REPORT TO THE CALGARY PLANNING COMMISSION

DEVELOPMENT PERMIT	ITEM NO: 10
	CPC DATE: 2008 February 21
	DP NO: DP2007-1554

PROPOSAL:
Apartment Building (135 Units) with offices and restaurant uses.

DP02

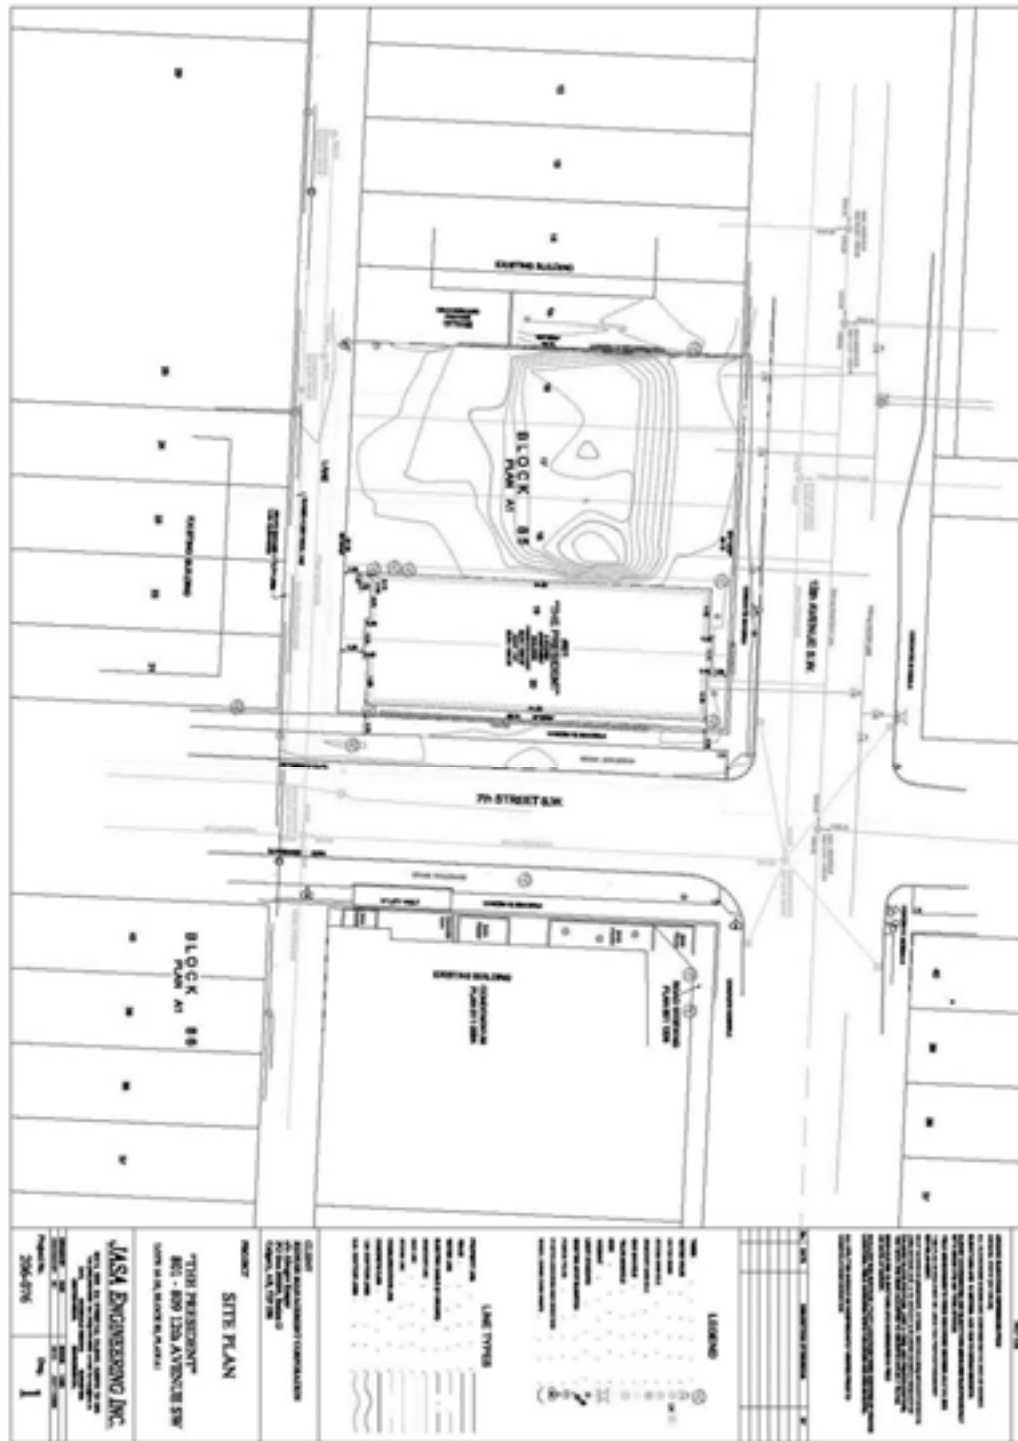
16. Label the traffic signal pole on the site plan, DP03.
17. Provide signage at street level indicating that visitor parking is available within the parkade. Indicate the location of this signage on the site plan.
